ECN/PCN No.: M1246

<b>Product Description:</b> Multilayer Ceramic Chip Inductor	<b>Abracon Part Number / Part Series:</b> AIMC-0603 Series	<input type="checkbox"/> Documentation only	<input checked="" type="checkbox"/> Series
		<input checked="" type="checkbox"/> ECN	<input type="checkbox"/> Part Number
		<input type="checkbox"/> EOL	
<b>Affected Revision:</b> F	<b>New Revision:</b> G	<b>Application:</b>	<input type="checkbox"/> Safety
			<input checked="" type="checkbox"/> Non-Safety

### 3.0 Part Number Identification

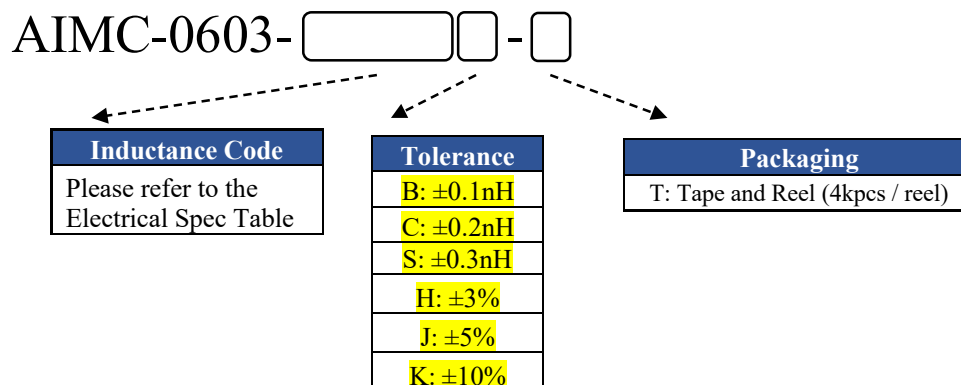
**Cause/Reason for Change:** Adding R33,R39,R43,R47 to the series. Adding B, C tolerance and removing D, K tolerances for parts from 1N0 to 5N6. Adding H tolerance for parts from 6N8 to R47. Updating to the Q, SRF value.
